A NATIONAL PARTY OF COLUMN	TATION/MODII	NO ATLON OF COMED A CIT		1. CONTRACT ID CODE	PAGE OF PAGES
AMENDMENT OF SOLIC	TATION/MODIF	FICATION OF CONTRACT		J	1   7

E. IMPORTANT: Contractor is not,	is required to si	gn this document and return	со	pies to the issuing office.	Will the literature of the state of the stat
<ul> <li>14. DESCRIPTION OF AMENDMENT/MODIL where feasible.)</li> <li>The Plans and Specifications accompanyi are hereby revised as indicated on the end Encls</li> <li>Bidding Schedule</li> <li>Bidders Questions and Answers and Transport of Transport o</li></ul>	ng IFB No. W91237-04- closed pages.	-B-007, for Town of Martin Phase 1A R			entucky
Except as provided herein, all terms and conditions of the do		or 10A, as heretofore changed, remains unchanged at 16A. NAME AND TITLE OF CO		<del></del>	or print)
15B. CONTRACTOR/OFFEROR	15C. DATE SIGNE		RICA	CIVIAIL.	16C. DATE SIGNED
		BY			
(Signature of person authorized to sign)		(Signature of Contracting Of	ficer)		11-May-2004

# TOWN OF MARTIN PHASE 1A REDEVELOPMENT SITE, MARTIN, KY

## IFB No. W91237-04-B-0007

- 28. The following drawing is hereby included for informational purposes only and is enclosed as Enclosure No. 3:
  - A. <u>Clearing-1.pdf</u>. For informational purposes only drawing providing detail on the clearing. (11x17 Drawing)

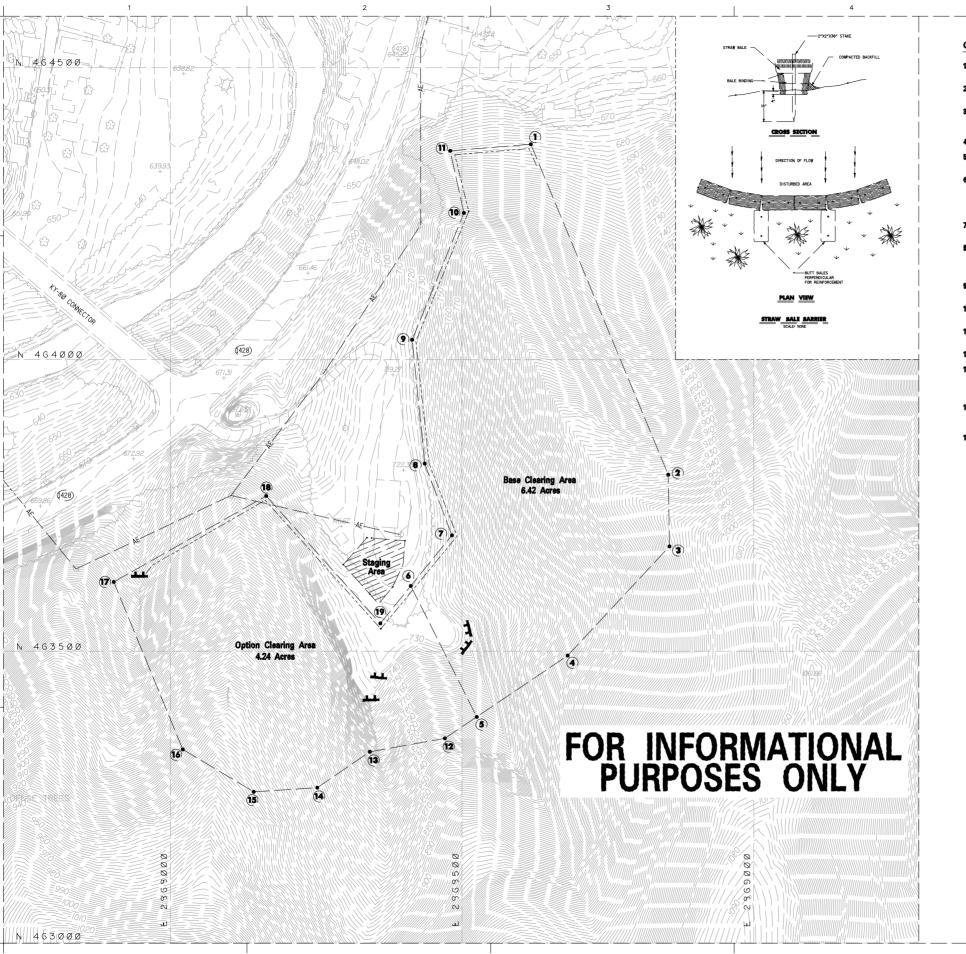
ANSWER: The contractor is clearing 10.66 acres at the site. Tree Stumps are not being removed. Drawing "Clearing-1.dgn" is attached showing the limits of the area that will be cleared prior to award of this contract.

ANSWER: The area shown on Drawing "Clearing-1.dgn" is only being cleared; grubbing of this area will have to be completed under this contract. There are other areas requiring clearing and grubbing within the CWL for this contract. Your price should be based on the contract specifications for clearing and grubbing as it applies to all these areas.
